SERVICE BULLETIN

ENGINE - FUEL AND CONTROL - REPLACEMENT OF FUEL TEMPERATURE THERMOCOUPLE WITH THERMOCOUPLE WITH STUD AND NUT TERMINATIONS - CATEGORY CODE 4 - MOD.ENG-73-0071

V2500-ENG-73-0071

Clipping schematic of EEC harness
Fig.3

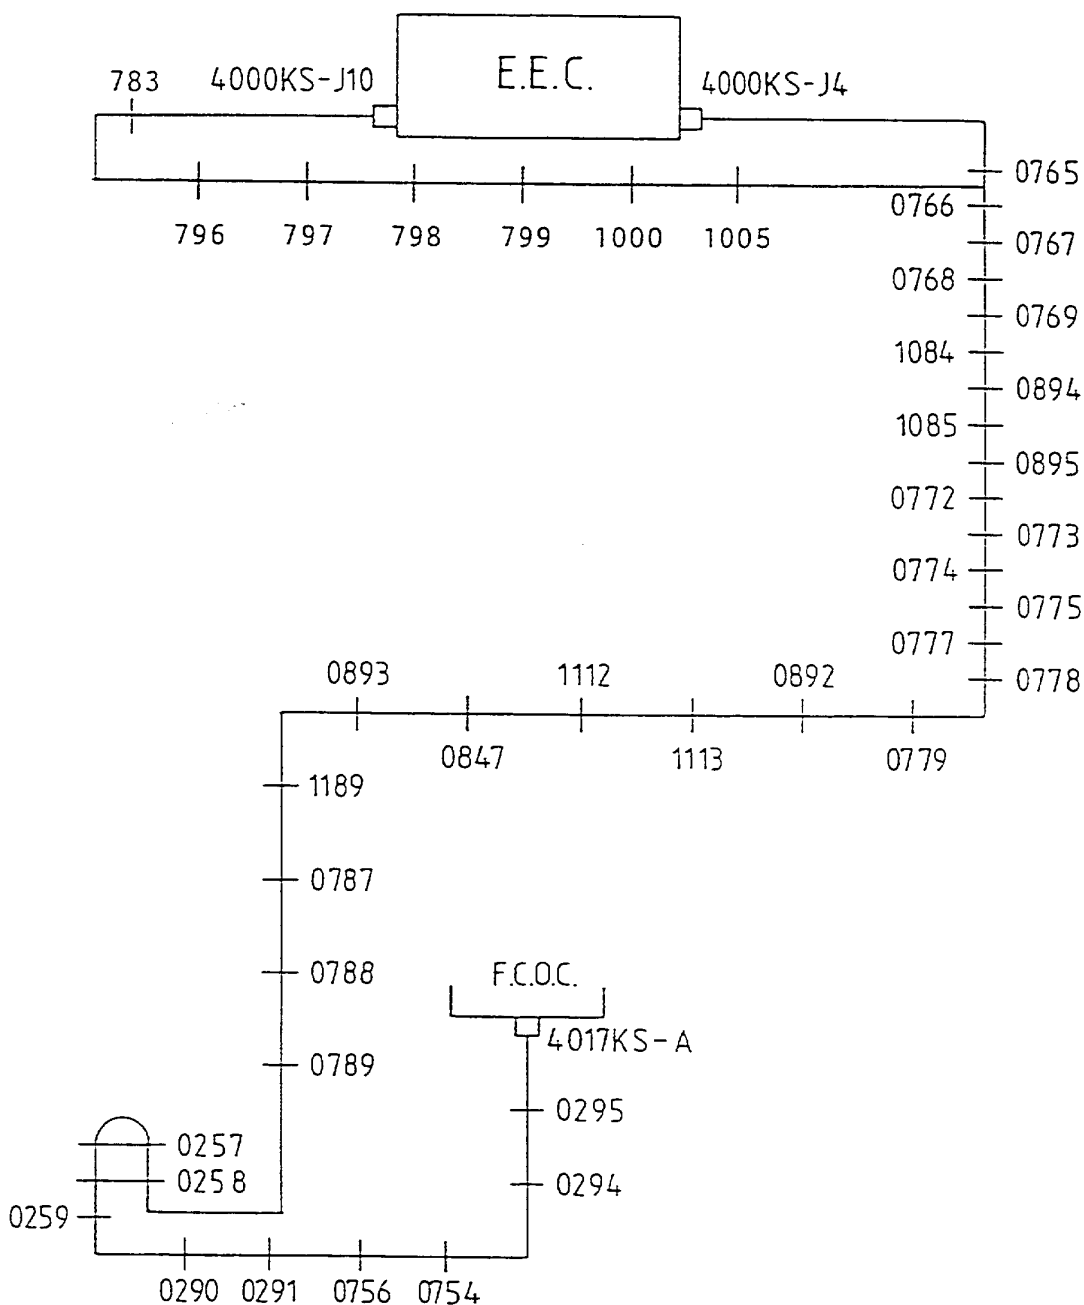
(4) Disassemble clipping point 0295 sufficiently to install the Harco leads through the clipping point until the datum ties are in position. Refer to Figures 3 and 6.

(13) Disassemble the 40 remaining clipping points for the EEC harness to install the Harco leads. Refer to Figures 1, 2 and 3.

(14) Install the new Harco leads through the 40 clipping points to follow the run of the EEC fan harness. Refer to Figures 1, 2 and 3.

- (1) Connect the 4000KS-J4 and 4000KS-J10 electrical connectors to the EEC and torque to 32 lbfin (3,6 Nm) using the IAE 1J12018 EEC harness wrench. Refer to Figure 5.
- (2) Assemble the 40 remaining clipping points, TORQUE the nuts to between 36 and 45 lbfin (4 and 5 Nm). Refer to Figure 3.
- (3) Tie the Harco leads to the EEC fan harness looms A and B using T085 lacing tape (white) at a maximum spacing of 1.97 in (50,0 mm) between tis. Refer to FIGURE 8.
- (4) Do a Fuel leak test on the Fuel Cooled Oil Cooler and the Fuel Filter Housing(Refer to 1.L (6)). Leaks are not permitted.
- (5) Do an operational test of the EEC (Refer to A.L.(9)).

View on fan case at E.E.C.
Fig.5

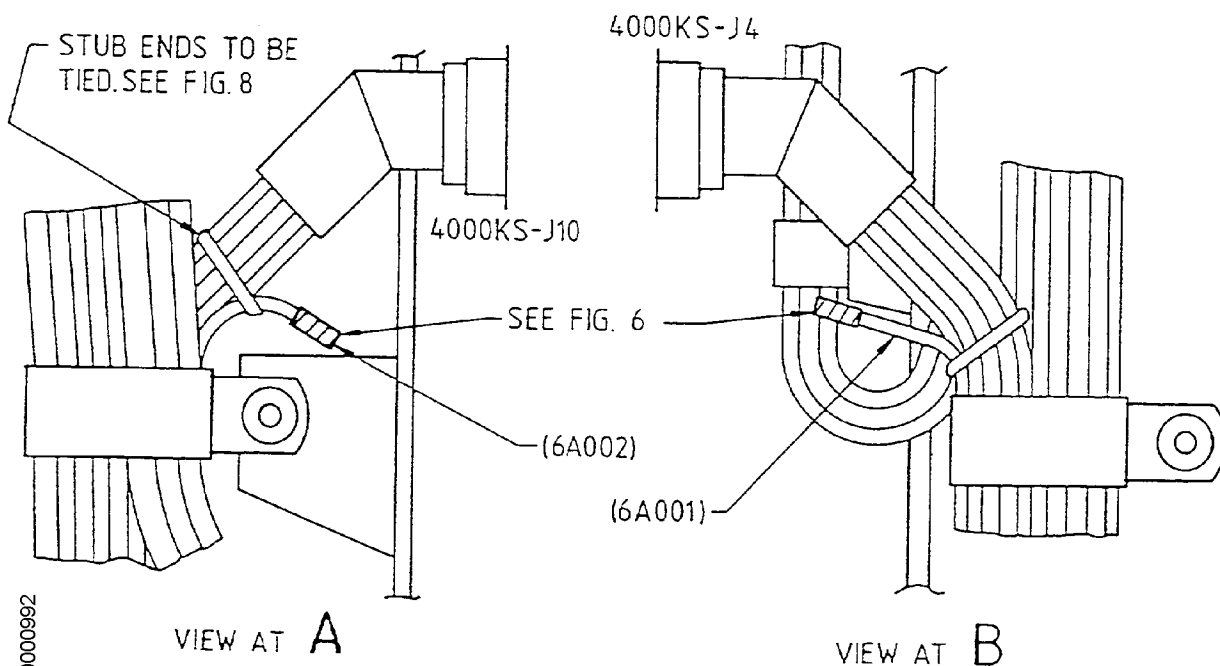
(4) Disconnect the electrical connectors 4000KS-J4 and 4000KS-J10 from the EEC using the IAE 1J12018 EEC harness wrench. Refer to Figures 1 and 5.

Schematic view on E.E.C. harness
Fig.6

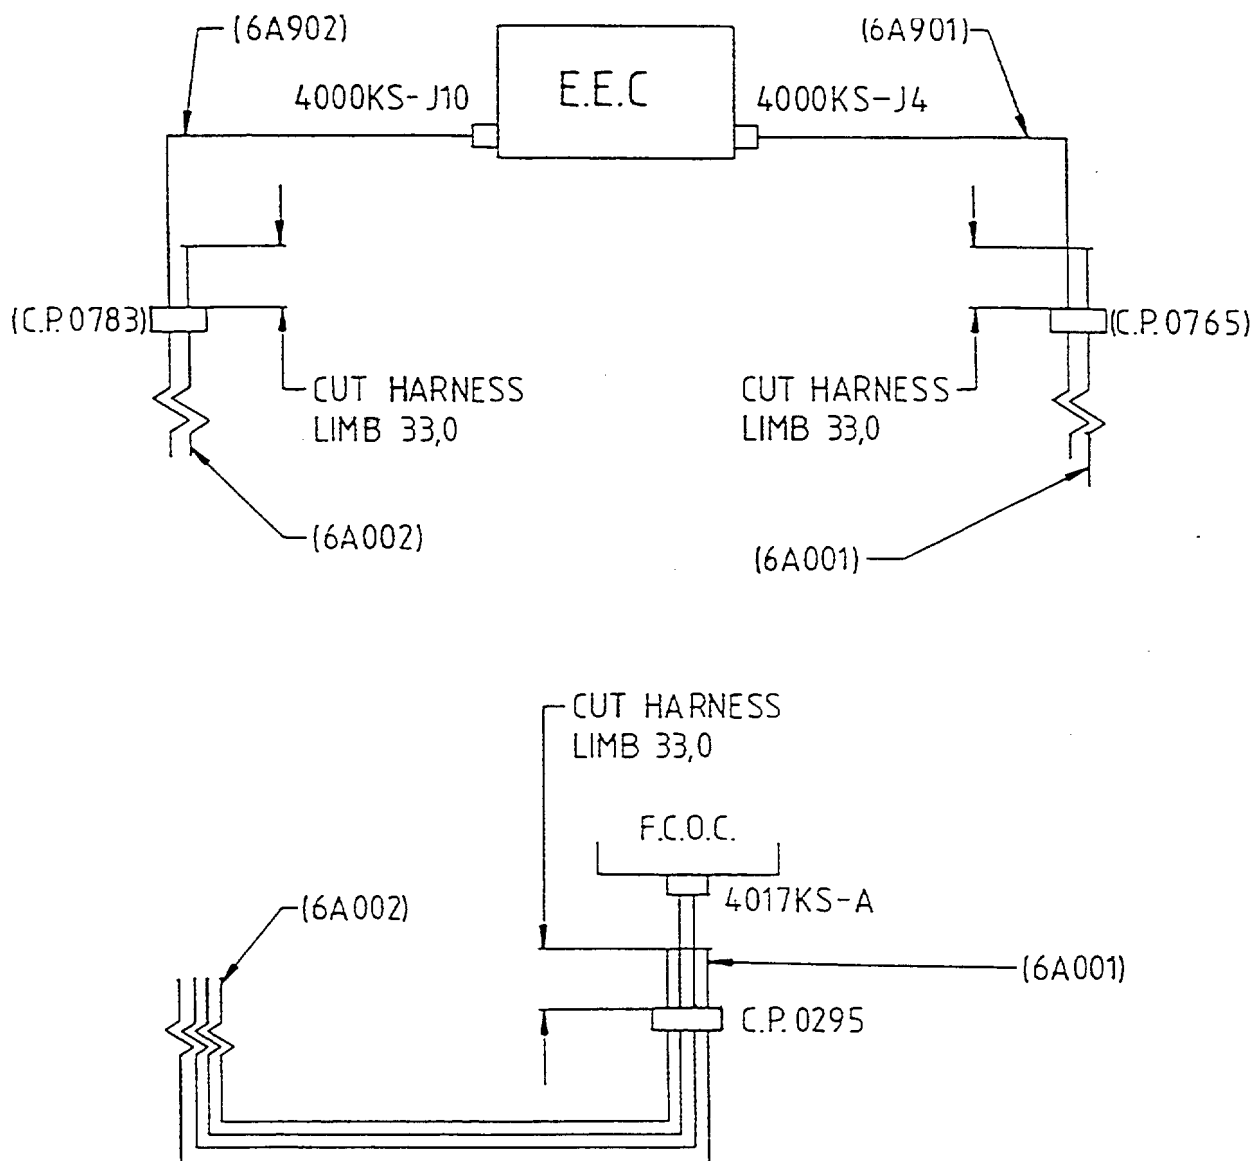
- (c) Cut off the two contacts from each connector J4 and J10, ensuring the identification sleeves remain attached to the harness. Record the length of the sheilding prior to cutting the harness. NOTE (1): This length will be used later to determine the length of the new harness ground (drain) wire. NOTE (2): Record the wire color corresponding to the C and D sockets for future reference when reassembling the connector assembly.

RE-IDENTIFY REMAINDER OF CUT CABLE, 6A001 & 6A002,
WITHIN THE HARNESS WITH EXISTING IDENTITY
NUMBER.

View showing position of datum ties
Fig.7

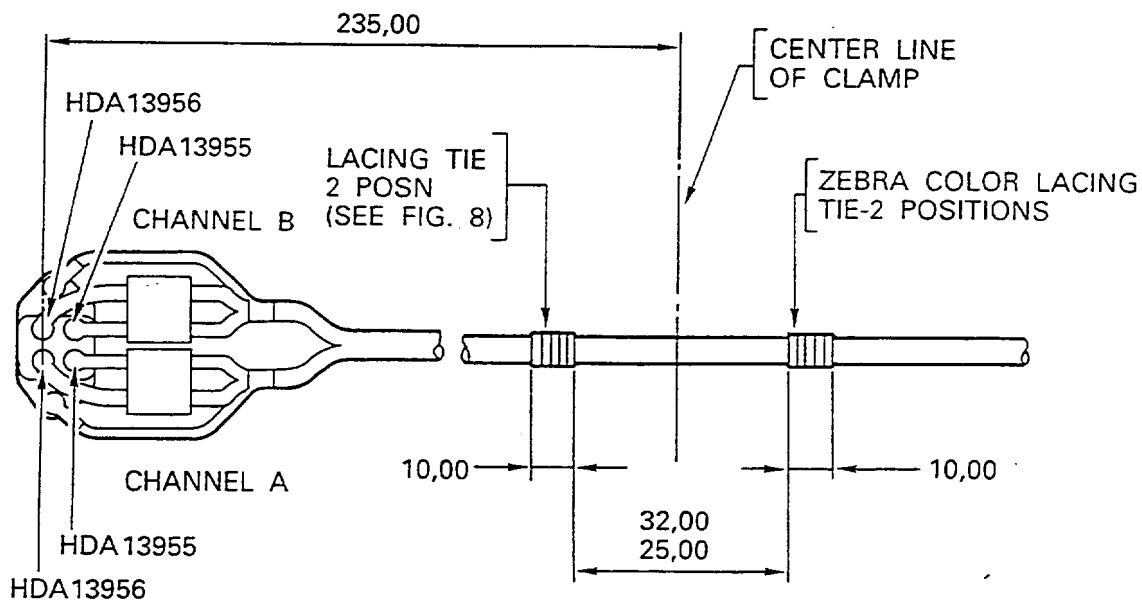
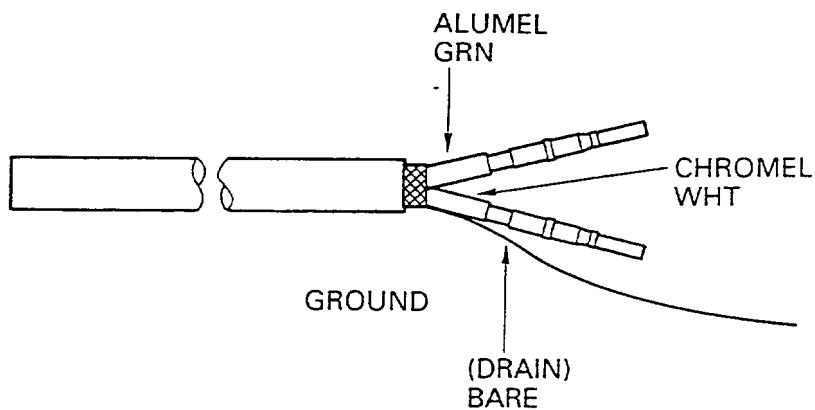
(3) Datum tie the two new Harco leads by V02-184 zebra lacing tape (718G) to dimensions as shown in Figure 7, "View showing position of datum ties".

(10) TORQUE the nuts (73-35-15, 01-130) P/N HDA13955) to between 15 and 18 lbfin (1,69 and 2,03 Nm) (Refer to 1.L.(3)). Refer to Figure 7.

(11) TORQUE the nuts (73-35-15, 01-140, P/N HDA13956) to between 18 and 22 lbfin (2,03 and 2,48 Nm) (Refer to 1.L.(3)). Refer to Figure 7.

- (a) Cut the Harco leads to a sufficient length to allow 2 re-uses at both J4 and J10 EEC connectors. Ensure the 20 gauge ground (drain) wire is at least as long as the original shielding. (Refer to 2.C.(7)(c) and Figure 7) Use standard workshop equipment

Removal/Installation of the Fuel Temperature Thermocouple
Fig.31

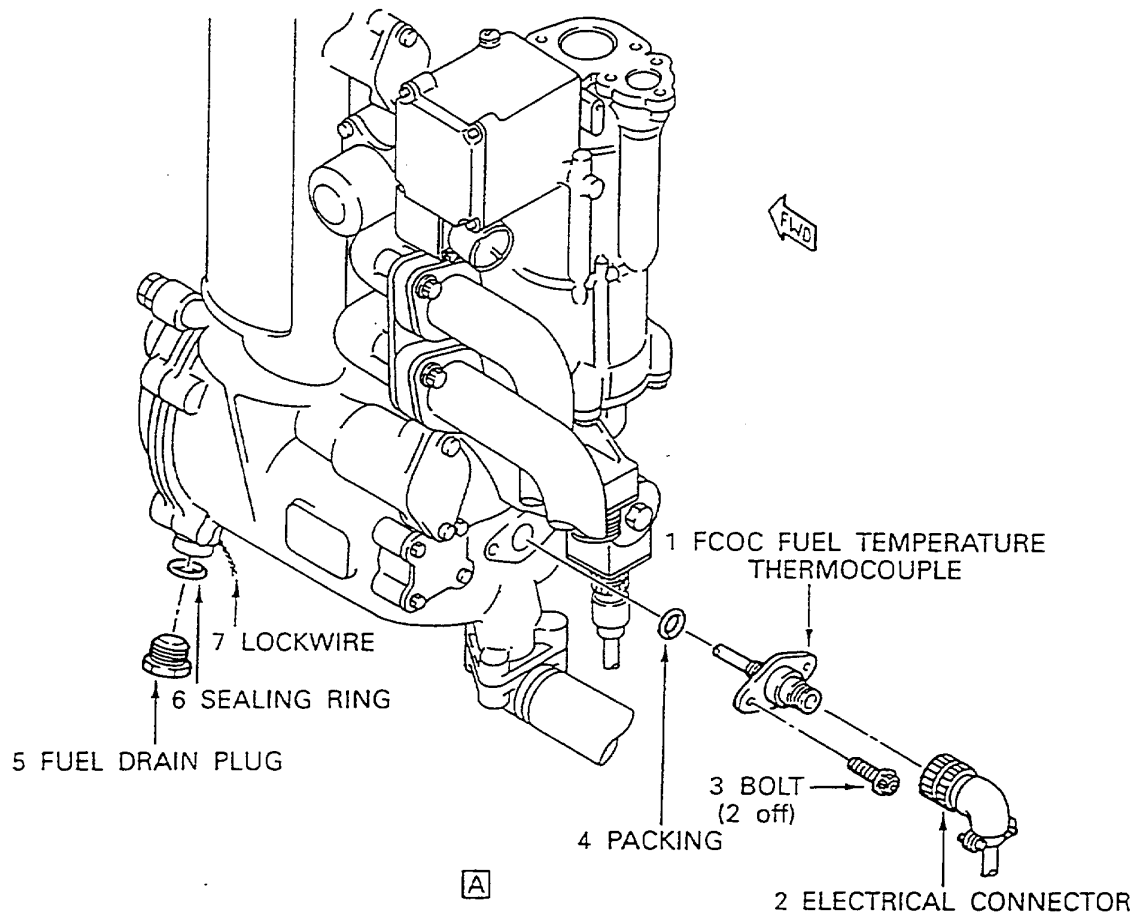
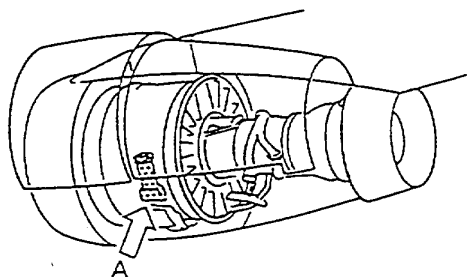
(6) Remove the Fuel Temperature Thermocouple (673-35-15, 01-100, P/N 5U0029) from the FCOC (Refer to Figure 31).

(a) Remove the two bolts (3) that attach the thermocouple to the FCOC.

(b) Remove the thermocouple (1) with the packing (4).

(5) Install the new Fuel Temperature Thermocouple (73-35-15, 01-100, P/N 5U0074 to the FCOC (Refer to Figures 31 and 32).

- (a) Lubricate the new packing (4) with clean V10-039 engine oil (Ref. 70-30-00).
- (b) Install the packing onto the new thermocouple (Refer to 1.L.(4)).
- (c) Use a clean lint free cloth made moist with V01-410 cleaning fluid.
- (d) Clean the backplate surrounding bolt hole area, the bolt underface and the ground lug faces of the new Harco leads.
- (e) Wipe clean by V02-099 lint free cloth.
- (f) Install the harness ground lug and 4W0169 bolt. TORQUE the bolt to between 85 and 105 lbfin (9,6 and 11,9 Nm). Refer to Figures 4 and 7.

NOTE: Ensure that the 10 studs on the fuel temperature thermocouple are uppermost on the unit prior to torquing the Bolts, to facilitate installation of the harness connections in a later operation.

- (g) Repeat operation (5) (c) to (5) (f) for the second 4W0169 bolt.
- (6) Install the fuel drain plug (Refer to Figure 31).
- (a) Lubricate the new sealing ring (6) with clean V10-039 engine oil (Ref, 70-30-00).
- (b) Install the sealing ring to the drain plug (5) (Refer to 1.L.(4)).
- (c) Install the drain plug with the sealing ring, to the FC0C.
- (d) TORQUE the drain plug to between 110 and 120 lbfin (12,4 and 13,6 Nm) (Refer to 1.L (3)).
- (e) Safety the drain plug with V02-126 wire (Ref. 70-30-00).
- (7) Rework the following parts.
